Product Change Notification

TE Connectivity

Product Change Notification: PCN-21-117278 **PCN Date:** 15-OCT-21

General Product Description:
PRODUCT GROUP DRAWING FOR TAB CONTACT 1.2 MM Produktgruppenzeichnung Flachstecker 1.2 mm

PRODUCT GROUP DRAWING FOR TAB CONTACT 1.2 MM
Produktgruppenzeichnung Flachstecker 1.2mm
CD-1418754

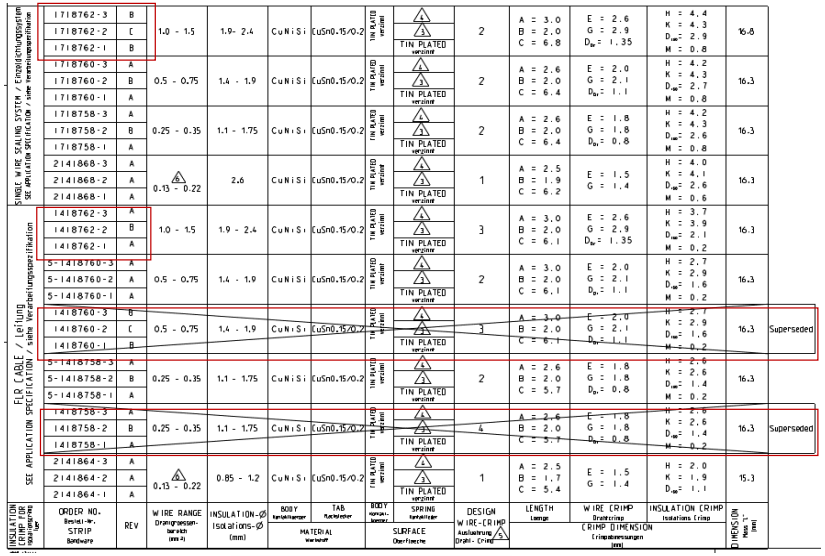
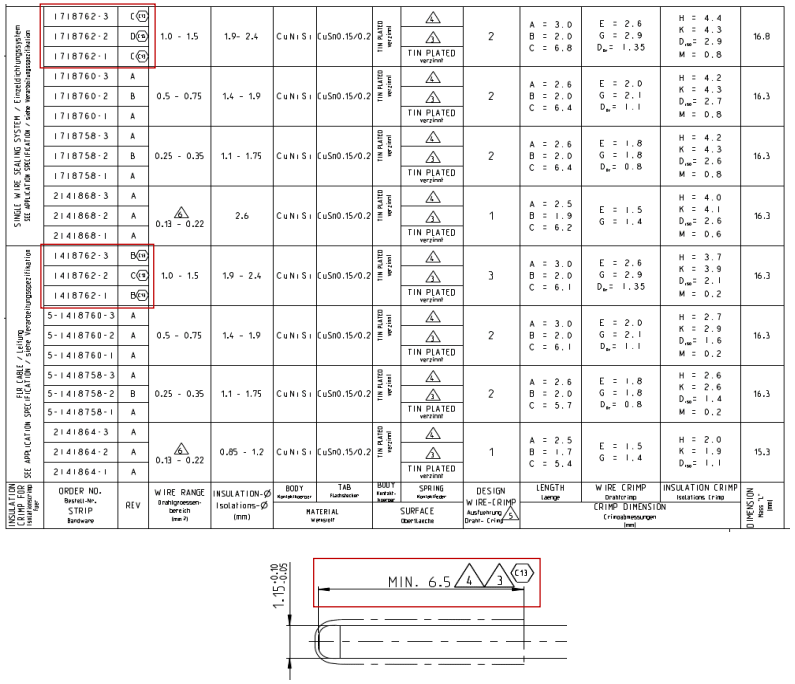
Description of Changes
1. Product Drawing update. Obsolete PNs 0-1418758-x and 0-1418760-x removed from customer drawing. 2. In conformity with the interface pin tip for MCON 1.2 tabs, 114-94201 we are homologizing and correcting the plated mating tab length to be 6.5mm for Au variants. 3. Higher temper class for body material of PN1418762-x and 1718762-x **Other attachments:** PCN-21-117278

x	Potential Impact for Customer	x	Product Type	x	Change Type	x	Kind of Change	x	Change Feature	Remark / Free text
x	No Customer Influence	x	TERMINALS	x	Form, Fit, Function	x	Material	x	Material Change	Higher temper class for body material of PN1418762-x and 1718762-x. Better electrical performance to pass European standard of slow motion bending test (LV214-2)
x	No Customer Influence	x	TERMINALS	x	No Form, Fit, Function	x	Revision Adjustment / Part Clarification	x	Clarification/correction	Product Drawing update. Obsolete PNs 0-1418758-x and 0-1418760-x removed from customer drawing. PNs 0-1418758-x superseded by 5-1418758-x and 0-1418760-x superseded by 5-1418760-x.
x	Revision adapted	x	TERMINALS	x	Form, Fit, Function	x	Drawing	x	Drawing Change	In conformity with the interface pin tip for MCON 1.2 tabs, 114-94201 we are homologizing and correcting the plated mating tab length to be 6.5mm for Au variants. These changes does not imply any change in function of the product as there are no applications at risk in the market. As per the industry standard: 114-94201 and EWCAP-001 indicates a required pin tip length of 7.4 +-0.2mm in total and <=1.8mm Plated. Bringing its minimum to 6.0mm.
